FINAL
Environmental Impact Report

**1145 Market Street
Office Building**

October 20, 1983

90

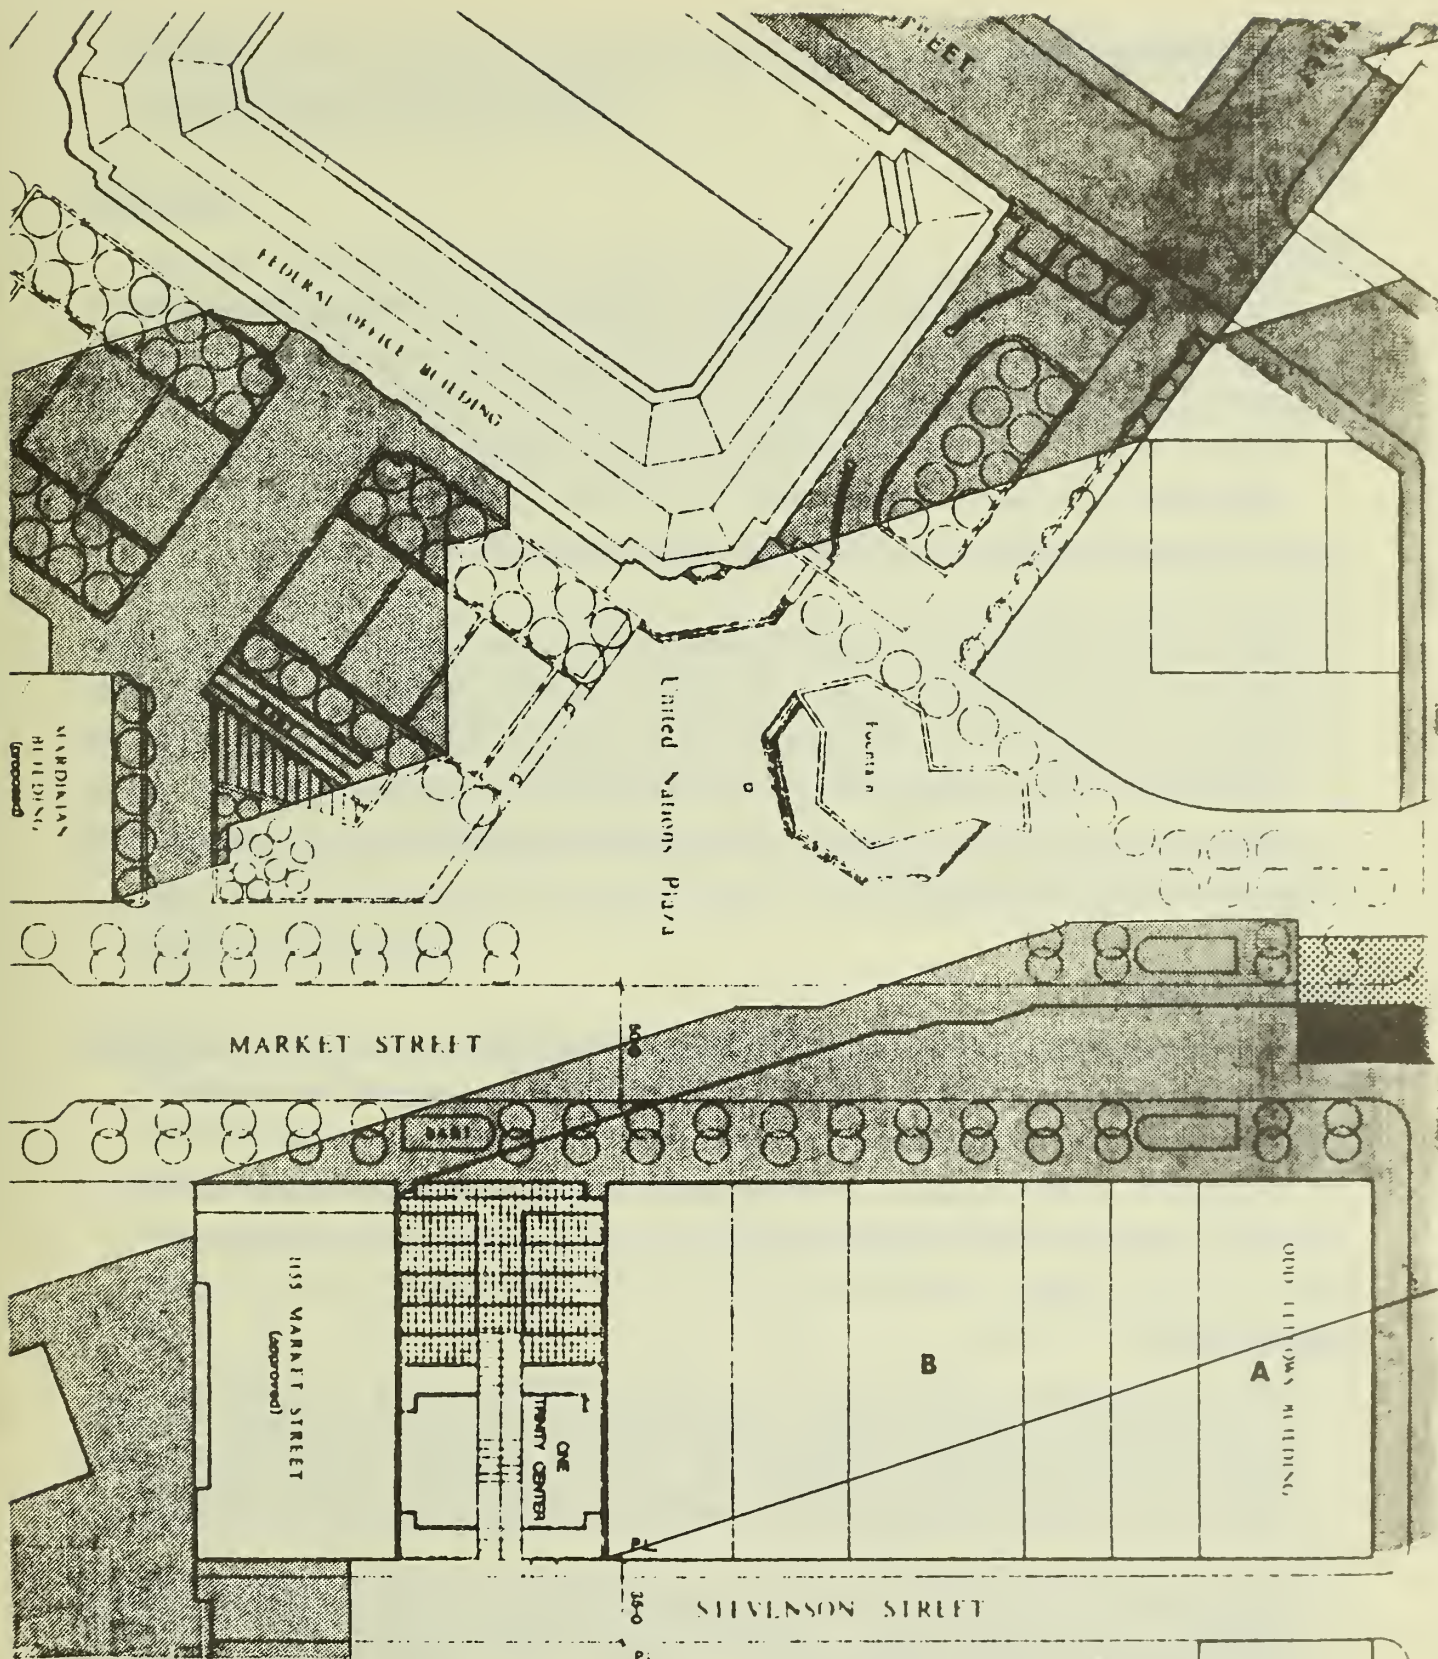
RESPONSE

The shadow analysis for the project was prepared as part of the Initial Study and Preliminary Negative Declaration issued by the Department of City Planning on May 21, 1982. The Initial Study is included as Appendix A of the EIR. On September 2, 1982, the Commission determined that an EIR was required on the proposed project providing further impact analysis for growth inducement cumulative transportation and cumulative air quality impacts; shadows were not identified as a potentially significant impact.

The shadow analysis indicates that the project would cast a shadow (assuming sunshine every day of the year) beyond the north curb of Market Street after 10:00 a.m. for about 200 days a year for about one and one-half to two hours on each morning during the months of January through March, September through December. The project would, in conjunction with other projects in the area, shadow a portion of the United Nations Plaza Fountain about 60 days a year for about one and one-half to two hours each day during the months of November through January. Although not precisely indicative of cloudiness conditions in San Francisco, it is noted that cloudiness measurements taken at the San Francisco International Airport show that

Shadow studies for the project have been prepared by Peter Bosselmann of the UC Berkeley Environmental Simulation Laboratory (ESL), which appear as Figures R-2 through R-10 on pages 25-33 of this document. The study reflects sun shading concepts and criteria introduced in the ESL report, Sun and Light for Downtown San Francisco, April 1983, which have been incorporated into the Department of City Planning's proposal for the Downtown Plan, August 1983. As compared to the shadow studies originally prepared for the project that appear on pages A-49 through A-56 of the EIR, the Bosselmann study uses the most current methodology.
